N1040A-01

Information Only Service Note

N1040A 33/60 GHz Dual Electrical Channel Module

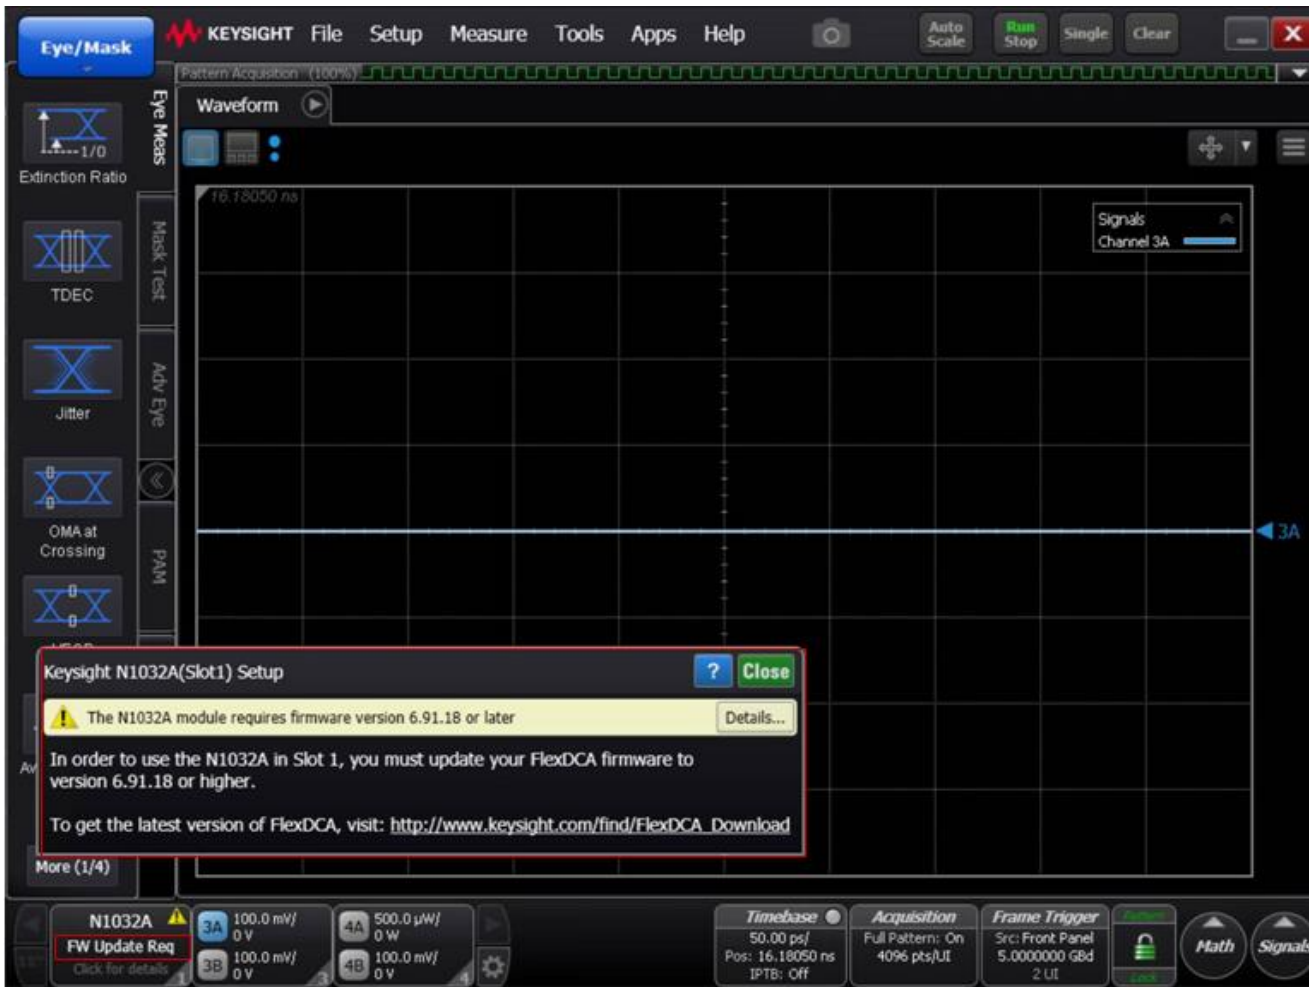
With the module installed in a DCA mainframe, if a message like the one below is displayed, FlexDCA must be updated to the indicated version (or later):

To update FlexDCA software, download from www.keysight.com/find/flexdca_download and install. While only the indicated version is required, updating to the latest version is recommended.
